TITLE: PID_module_A_5

PID "Current"

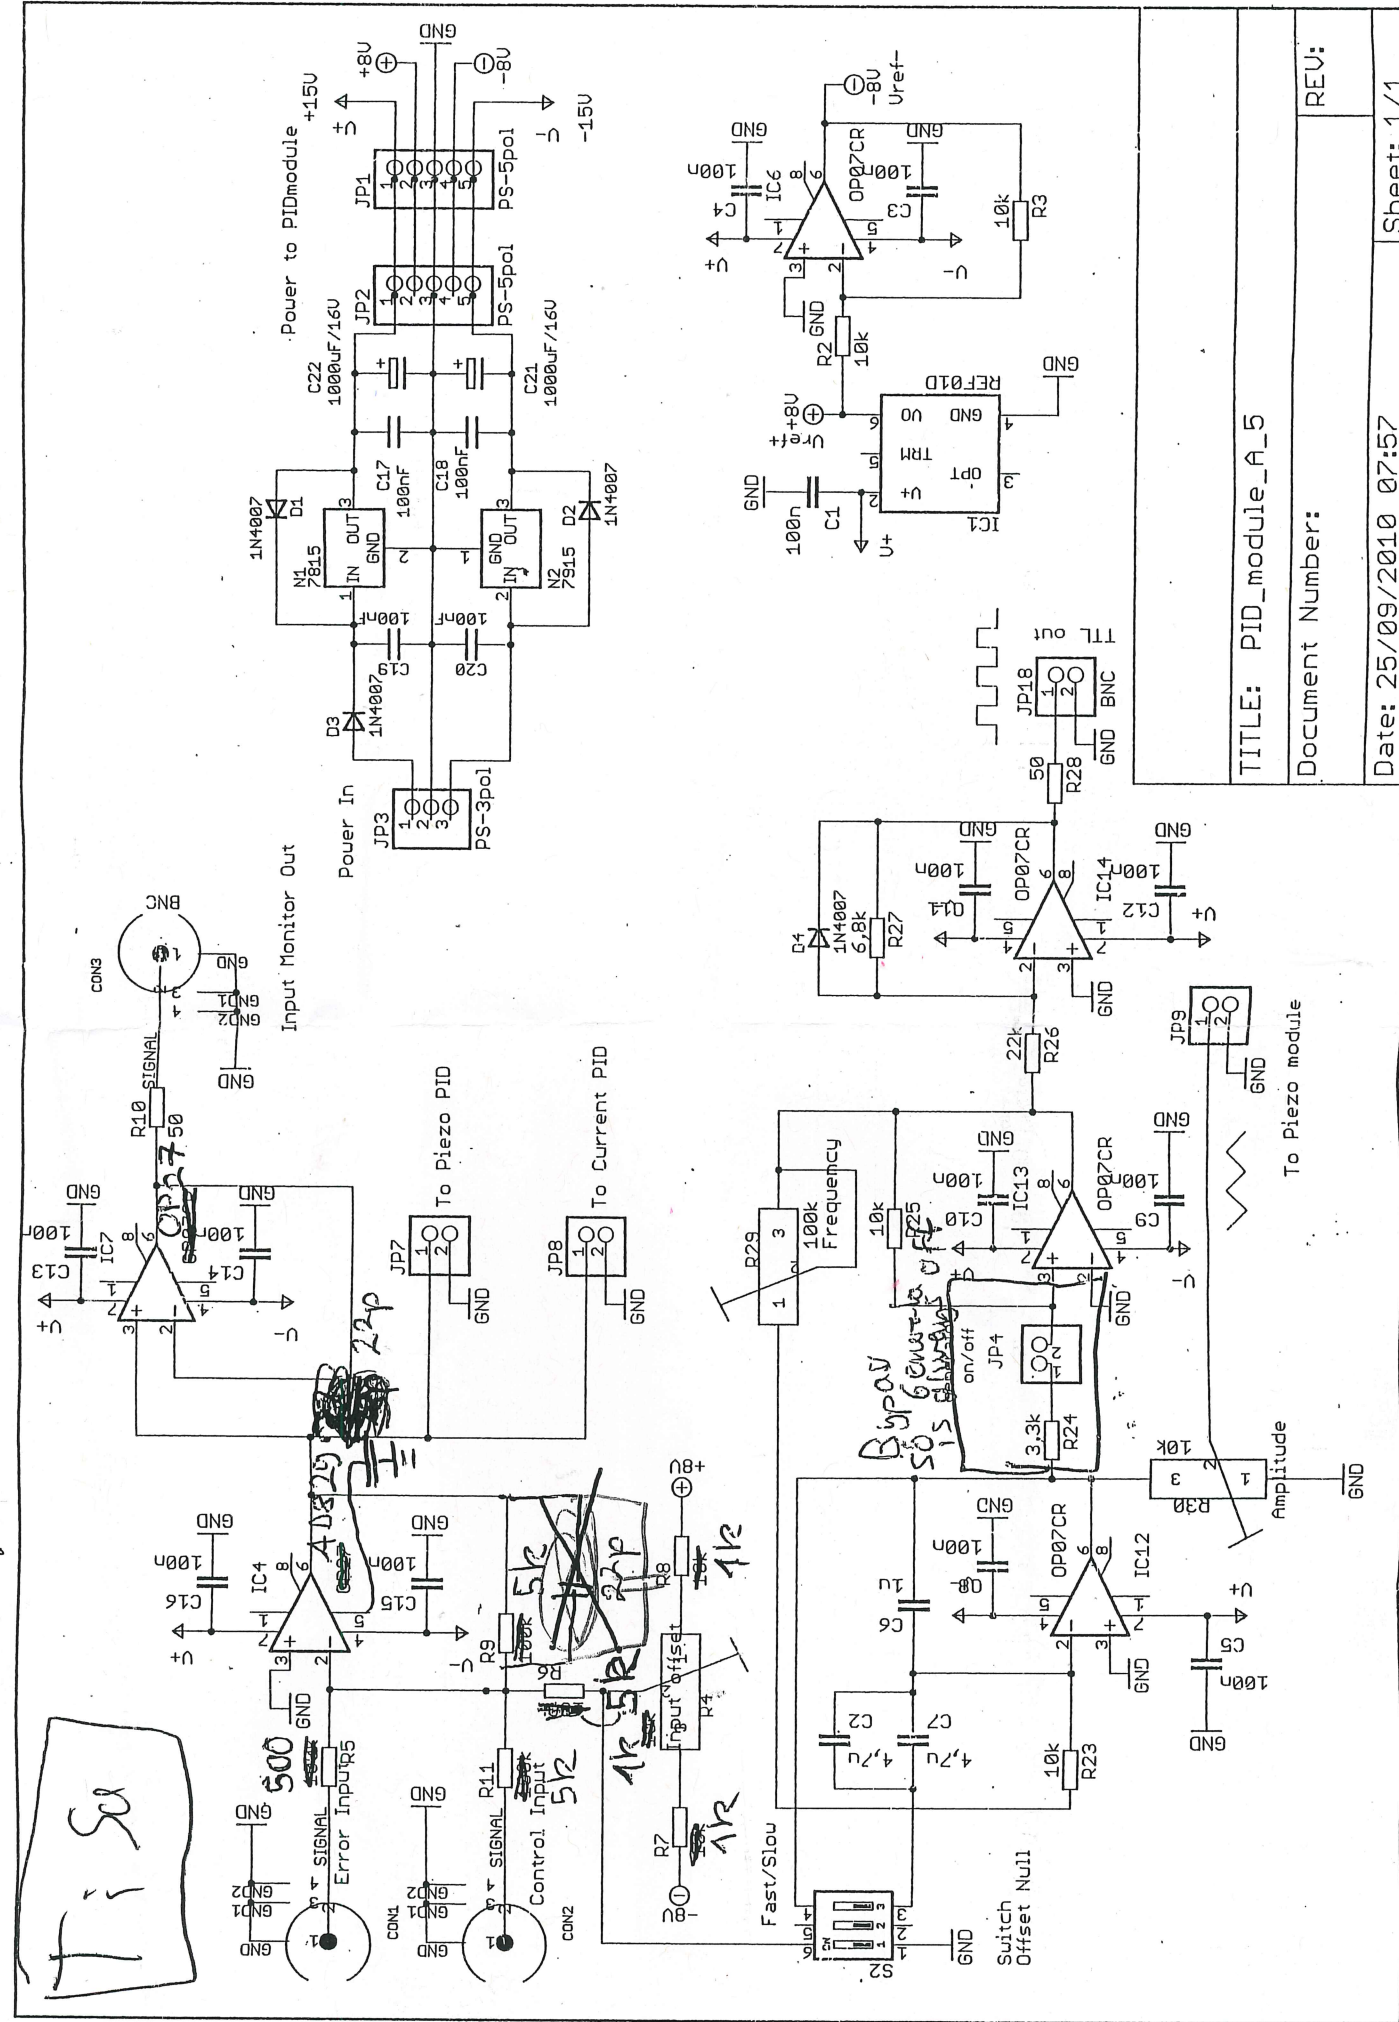
~ 1MHz Bandwidth limited by capacitor in opamp feedback

Bandwidth limited to ≈ 100 kHz ~~capacitors~~ ~~capacitors~~ ~~capacitors~~

Ccomp @ pin 5 for AD829

Smaller Resistor to reduce Johnson - Noise

Extra Gain @ acoustical Frequencies
